Access Compliance Report

Public Rights-of-Way

Intersection ID: 29777	Main Street: REA_RD	Cross Street: WILLIAMS_POND_LN	Location: E
ADA ID: 8C2F7483DEDC	Ramp Type: Perp	Initial Pass/Fail: Fail	Overall Compliance: No
Codes/Mitigation Info/Possible Solution		Field Measurements/Component Compliance

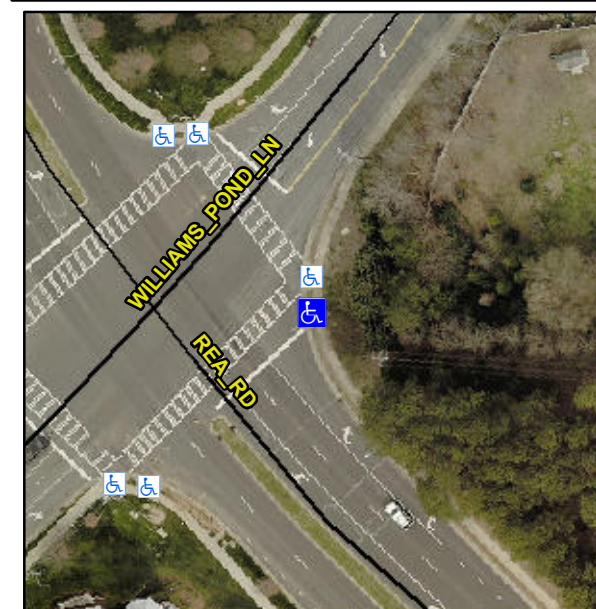
R304.2.2, R304.5.3

Compliance	Description	Data	Compliance	Description	Data
N/A	Ramp Length (in)	101.0	No	Ramp Slope (%)	8.6
Yes	Ramp Width (in)	53.0	No	Ramp XSlope (%)	4.3
N/A	Flare Type LT	N/A	N/A	Flare Type RT	N/A
N/A	Flare Slope LT (%)	N/A	N/A	Flare Slope RT (%)	N/A
N/A	Flare Traversable LT?	N/A	N/A	Flare Traversable RT?	N/A
N/A	Landing Length (in)	N/A	N/A	DWS Provided?	N/A
N/A	Landing Width (in)	N/A	N/A	DWS Contrast?	N/A
N/A	Landing Slope (%)	N/A	N/A	DWS Length (in)	N/A
N/A	Landing X Slope (%)	N/A	N/A	DWS Full Width?	N/A
N/A	Landing Curb? (Y/N)	N/A	N/A	DWS Offset (in)	N/A
N/A	Shared Landing?	N/A			
N/A	Gutter Ponding?	N/A	N/A	Gutter Slope (%)	N/A
N/A	Gutter Lip Ht (in)	N/A	N/A	Gutter X Slope (%)	N/A
N/A	Painted X Walk1?	Yes	N/A	Painted X Walk2?	N/A
	X Walk 1 Direction	To SW		X Walk 2 Direction	N/A
N/A	X Walk 1 Width (in)	107.0	N/A	X Walk 2 Width (in)	N/A
	X Walk 1 Slope (%)	3.0		X Walk 2 Slope (%)	N/A
	X Walk 1 X Slope (%)	1.4		X Walk 2 X Slope (%)	N/A

**Remove & Replace Entire Ramp.
Restripe Crosswalk.**
